# RANDALL SCHOOL

65 I ST SW, WASHINGTON, DC

ZONING COMMISSION HEARING  
MARCH 29, 2018

## PROPOSED MODIFICATIONS

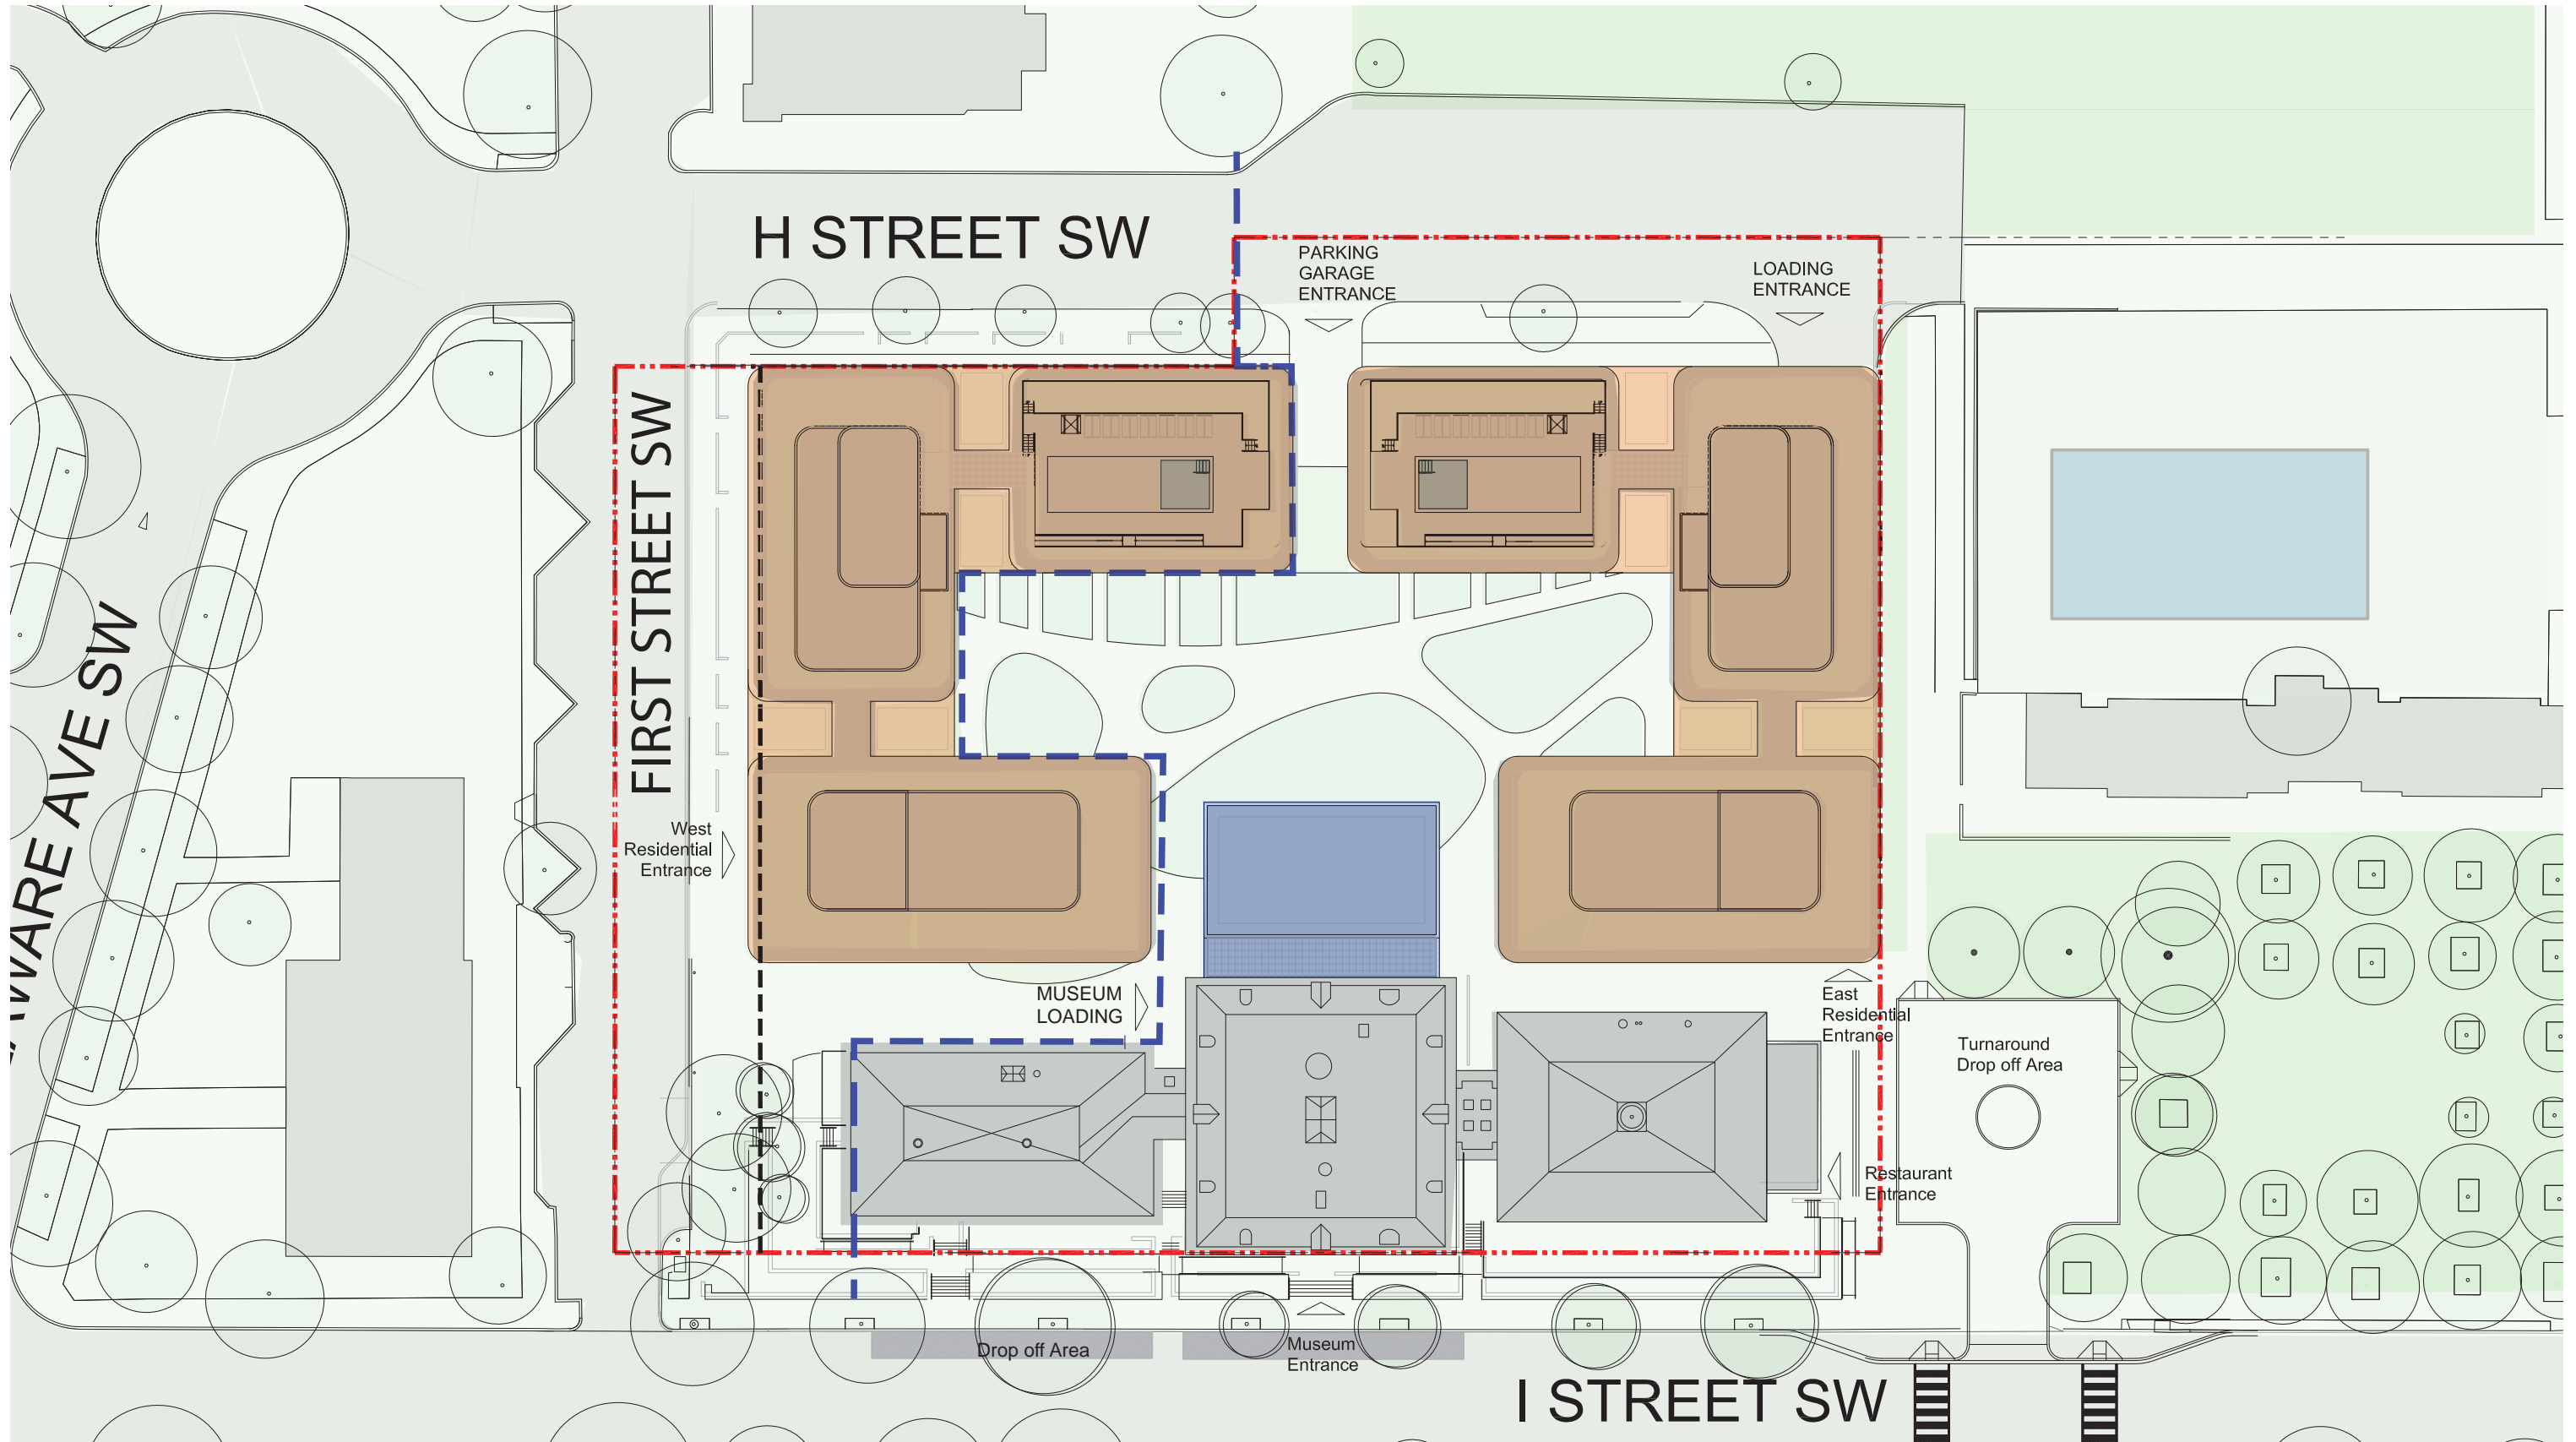
1. INCREASE IN OPEN SPACE AND FUNCTIONALITY OF COURTYARD
2. REMOVAL OF CANTILEVER WINGS TO OPEN UP COURTYARD
3. REMOVAL OF MUSEUM ADDITION
4. RESTORATION OF FRONT AND REAR ELEVATIONS TO HISTORIC 1906 CENTER BLOCK BUILDING
5. REMOVAL OF SECOND ENTRANCE AT WEST WING

## PROPOSED MODIFICATIONS

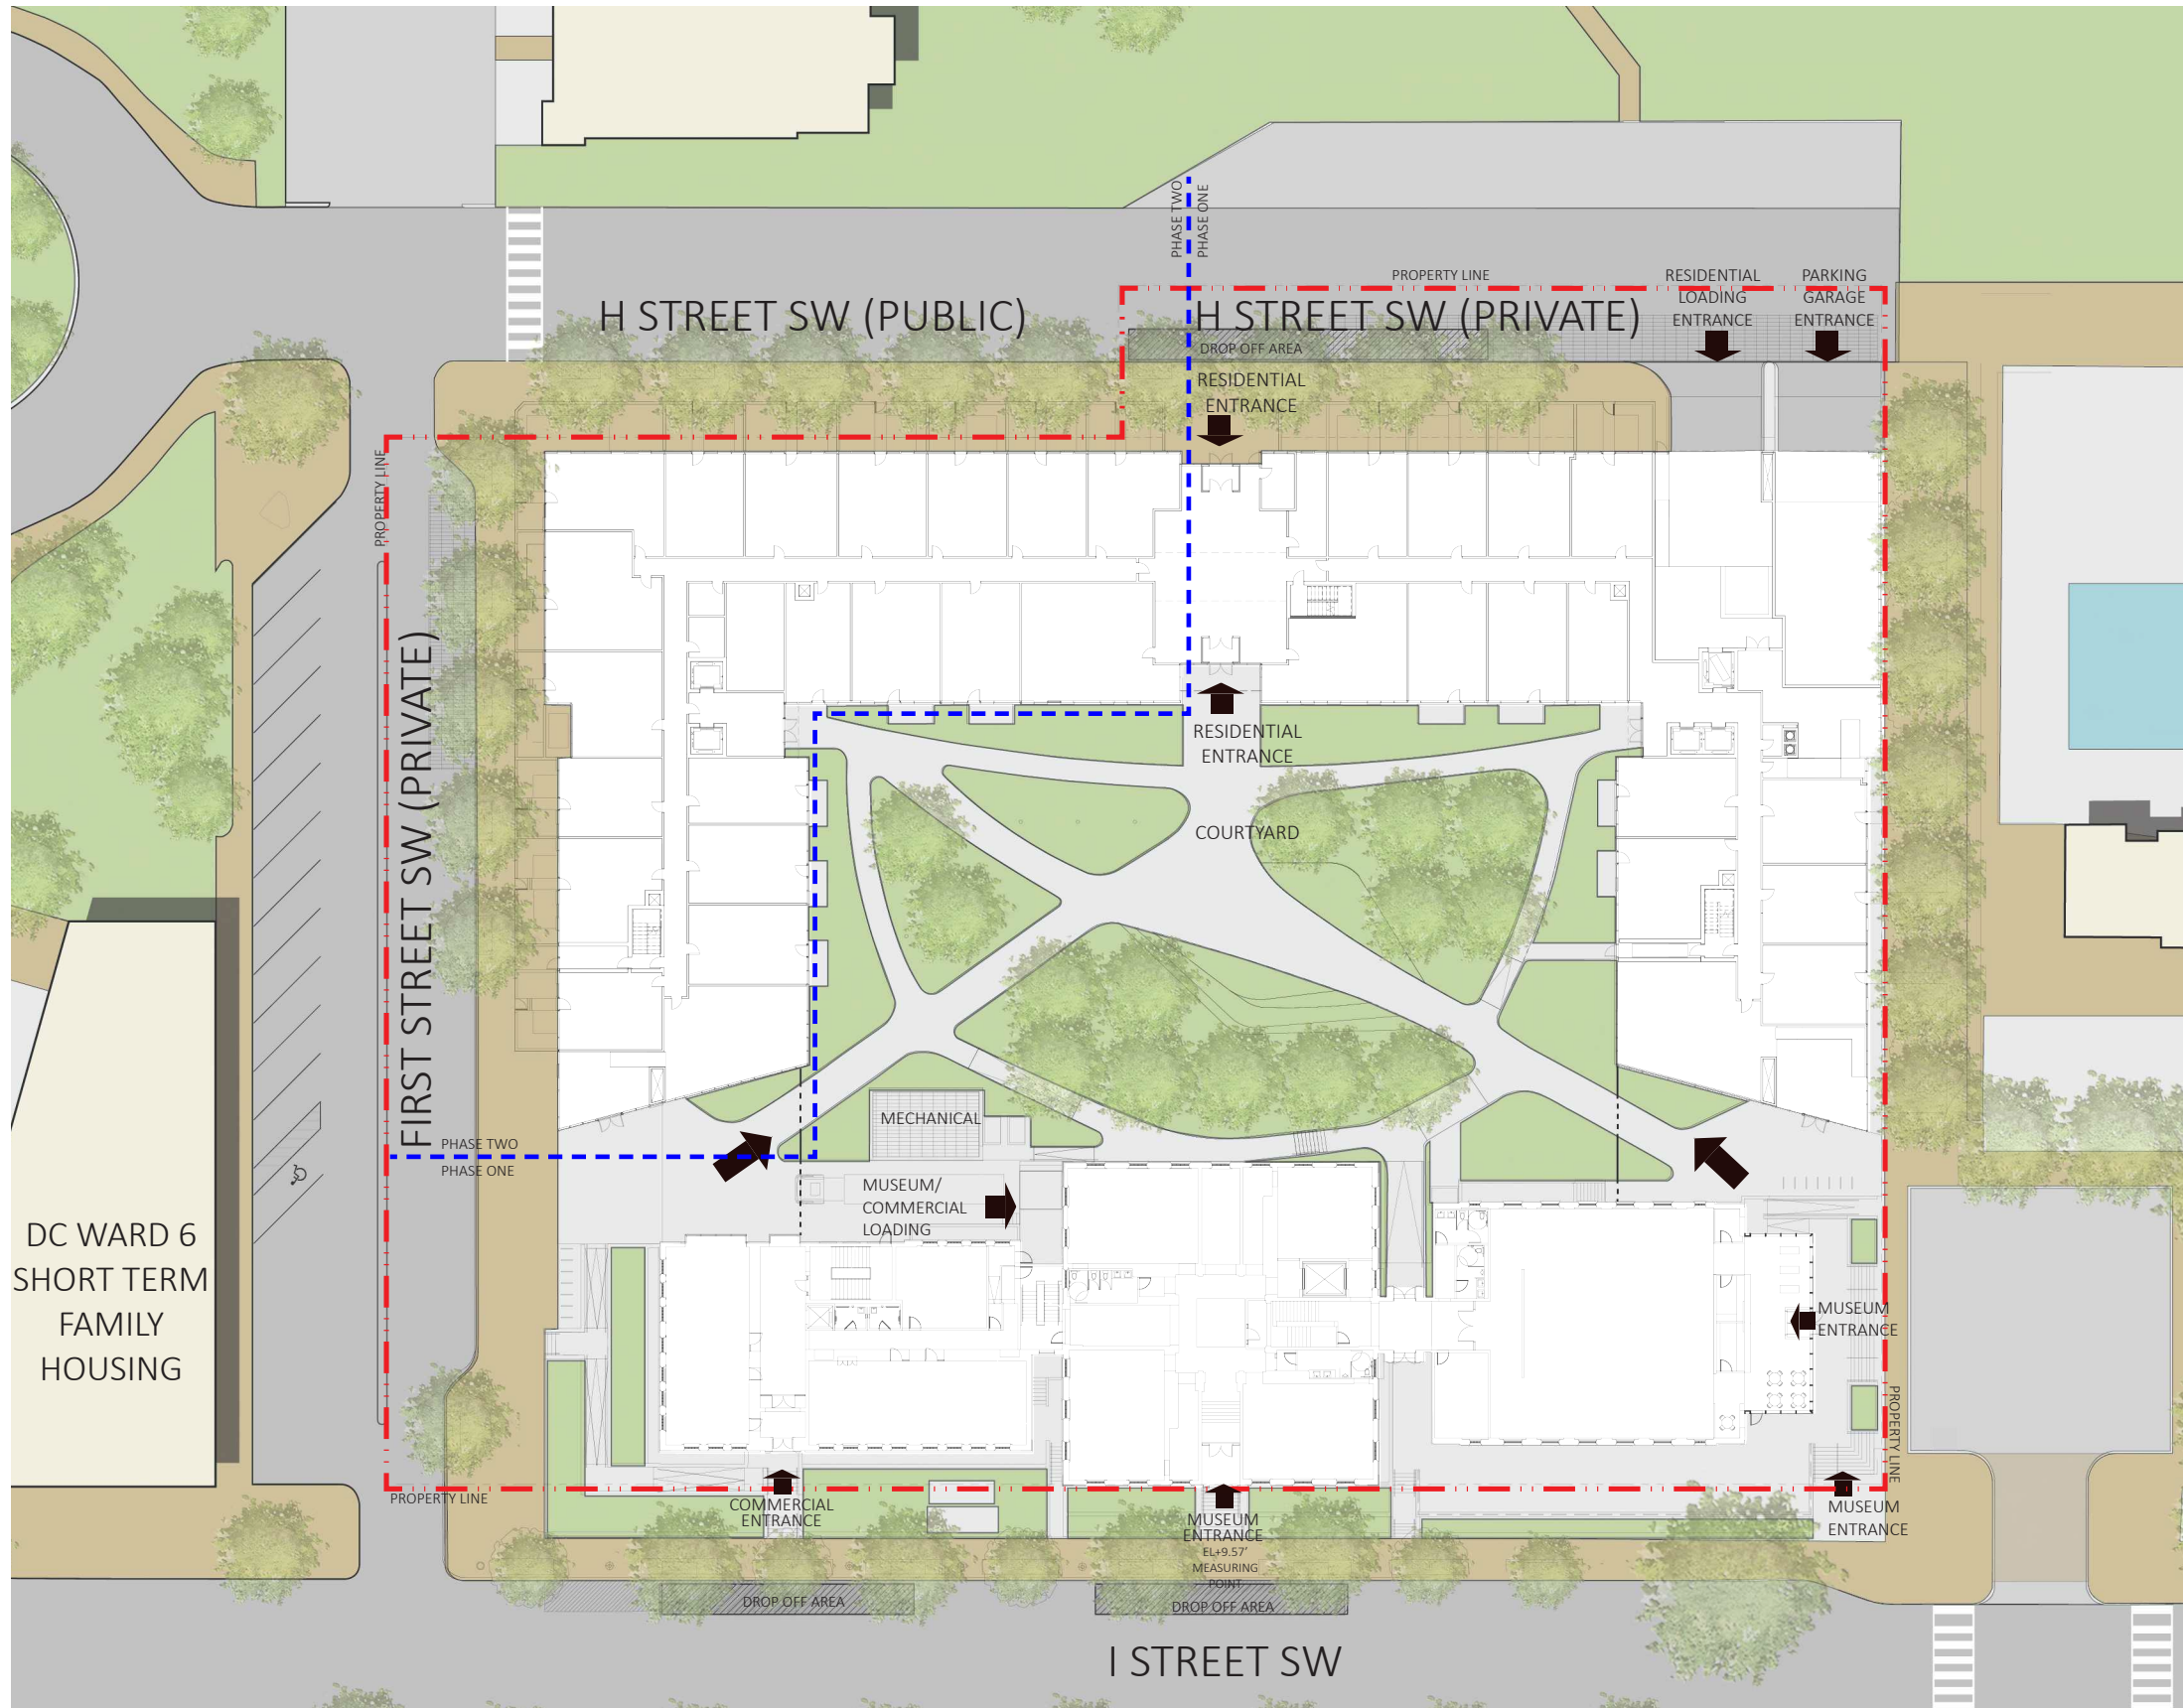
1. INCREASE IN OPEN SPACE AND ACCESS TO COURTYARD
2. MAIN ENTRANCE OF MUSEUM AT MODERN EAST WING ADDITION
3. REMOVAL OF SECOND ENTRANCE AT WEST WING
4. RESIDENTIAL ENTRANCE MOVED TO H STREET SW / CENTRAL COURTYARD
5. RESIDENTIAL BUILDING JOINED TO ELIMINATE DUAL APARTMENT CORES
6. RELOCATION OF PARKING GARAGE ENTRANCE TO NE CORNER OF SITE
7. RELOCATION OF LOADING TO AT-GRADE BERTH IN NE CORNER

## PROPOSED MODIFICATIONS

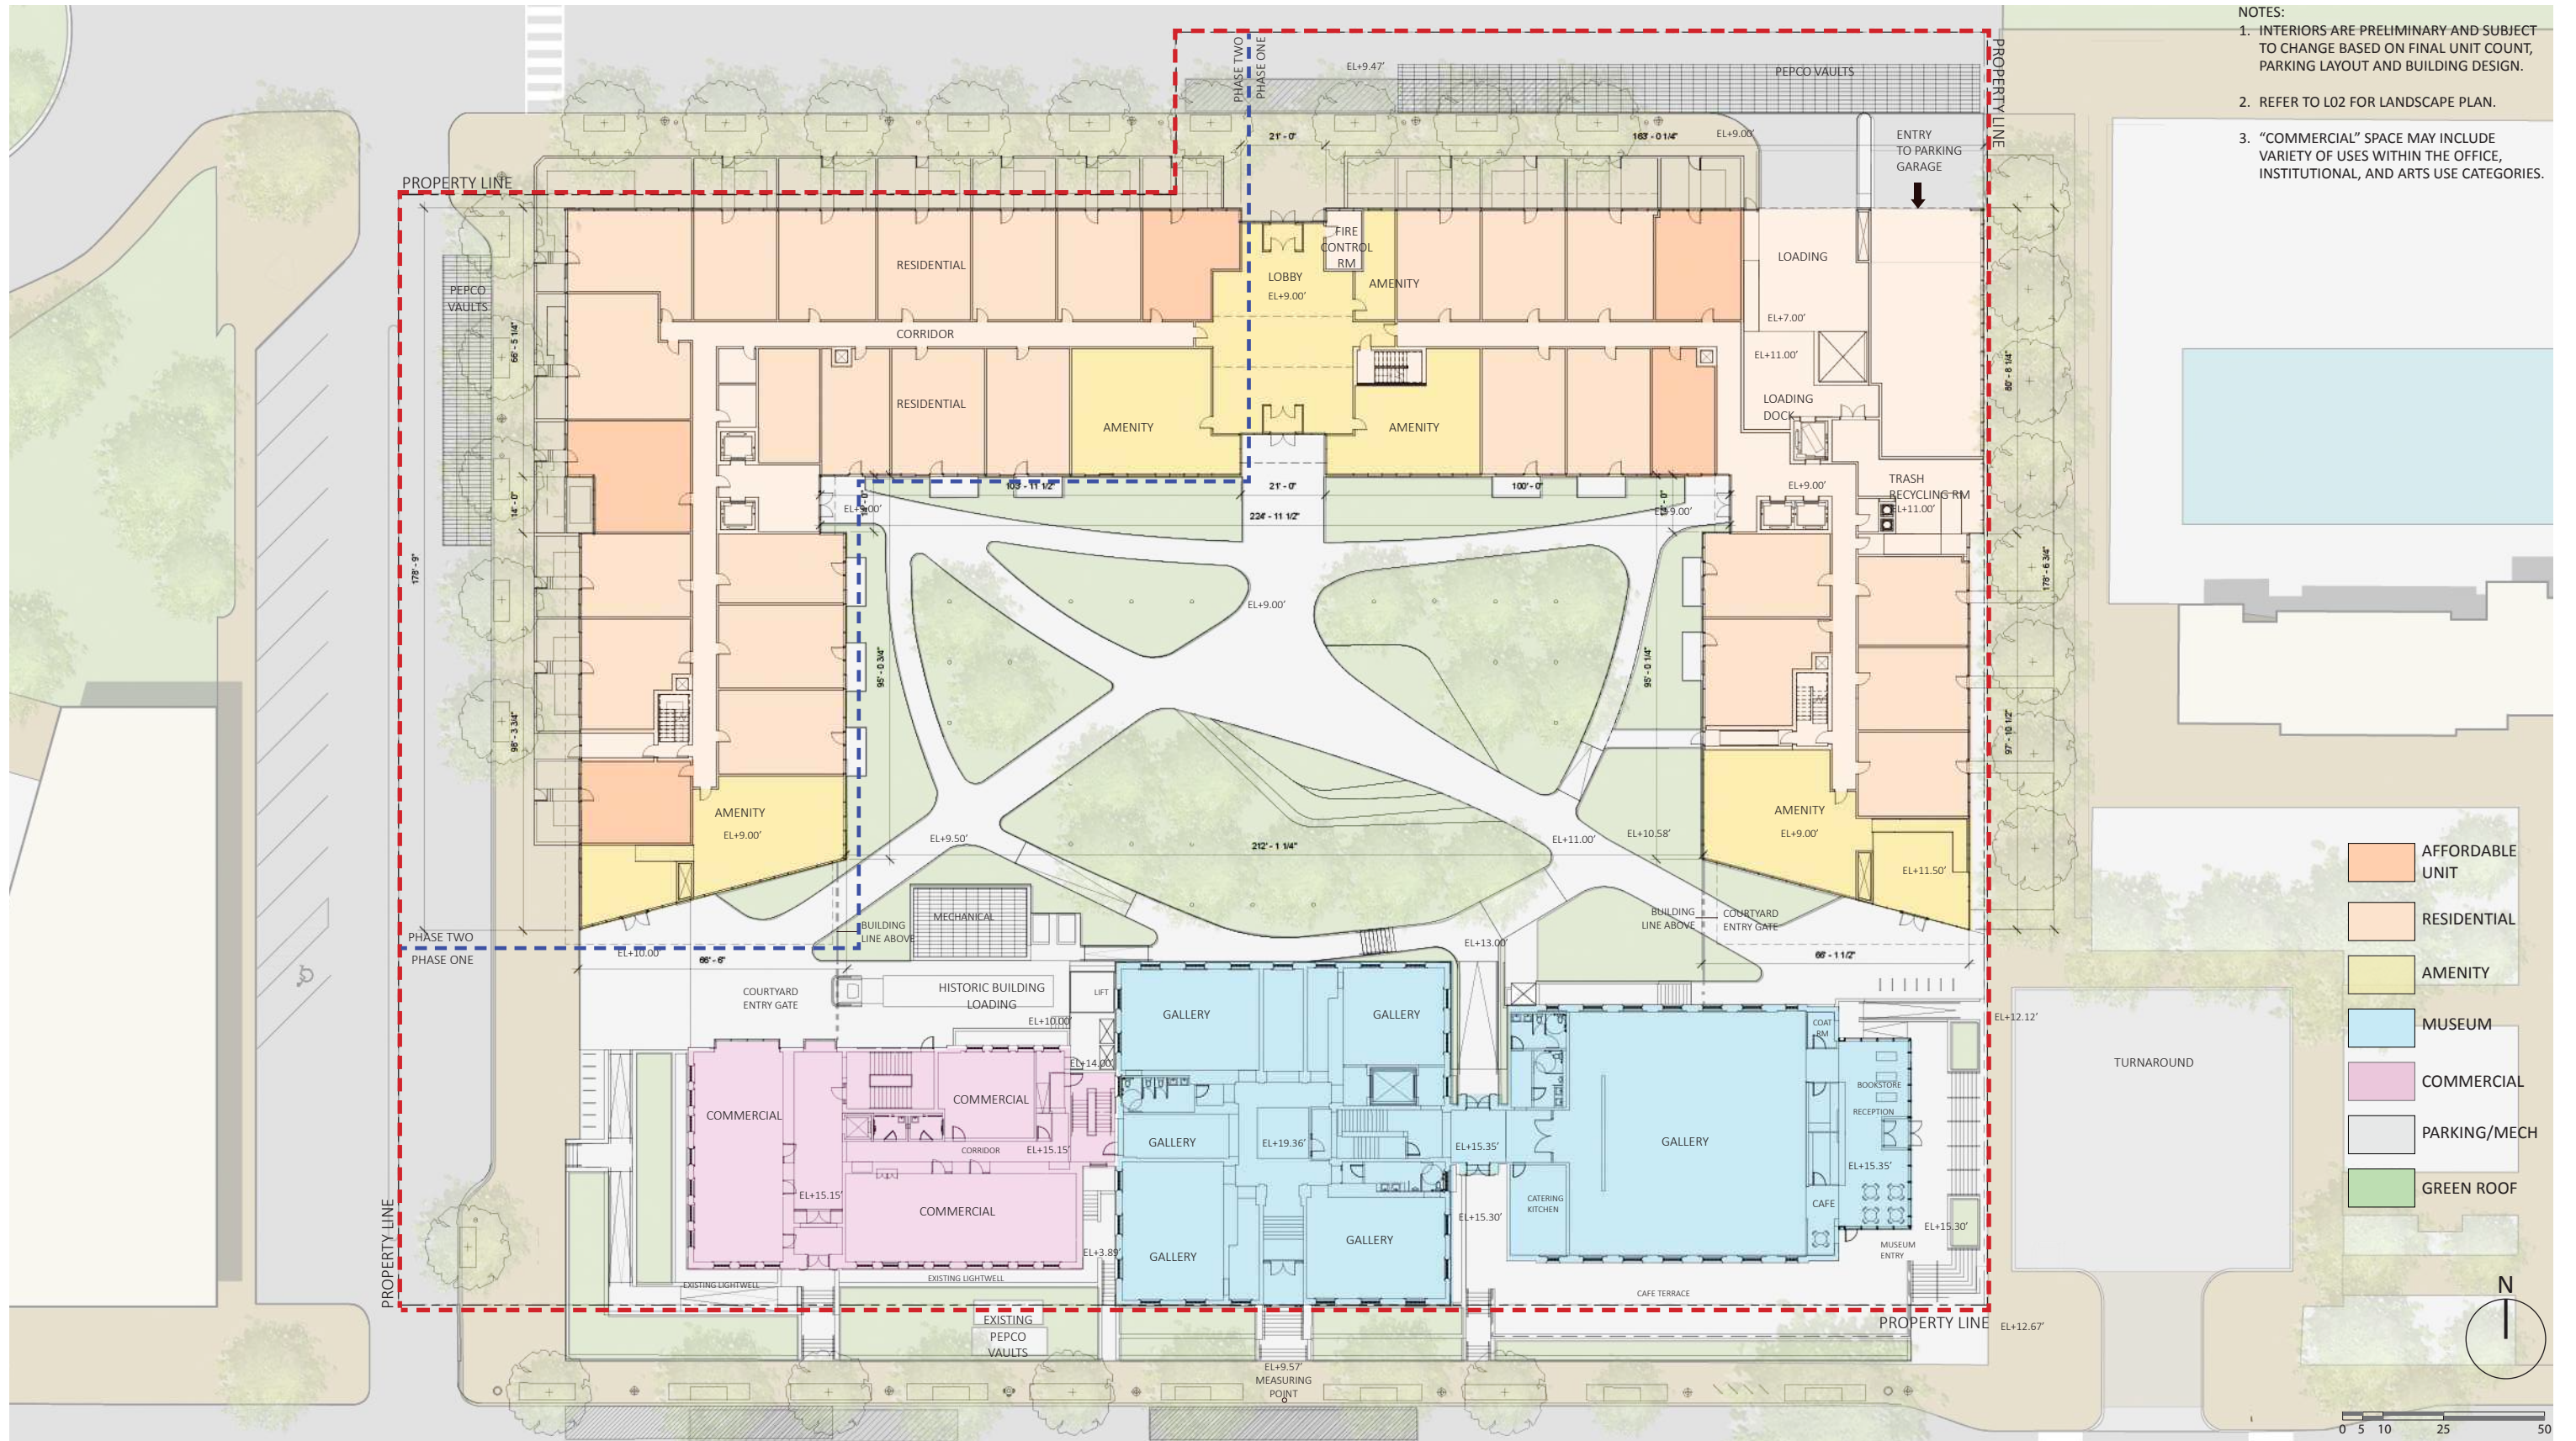
1. MORE REGULARIZED METAL PANEL AND GLASS PATTERN
2. LARGER, OCCUPIABLE BALCONIES ADDED VERSUS PREVIOUS JULIET BALCONIES ON THE UPPER FLOORS 7-12
3. MORE ARTICULATION OF MASSING BETWEEN THE FLOORS 1-6 AND FLOORS 7-12 TO BREAK DOWN THE MASSING
4. MORE GLASS ADDED AT THE PENTHOUSE AMENITY SPACES
5. RESIDENTIAL BUILDING FACADE SIMPLIFIED TO ACT AS BACKDROP TO AND TO HIGHLIGHT DETAILED HISTORIC RANDALL SCHOOL
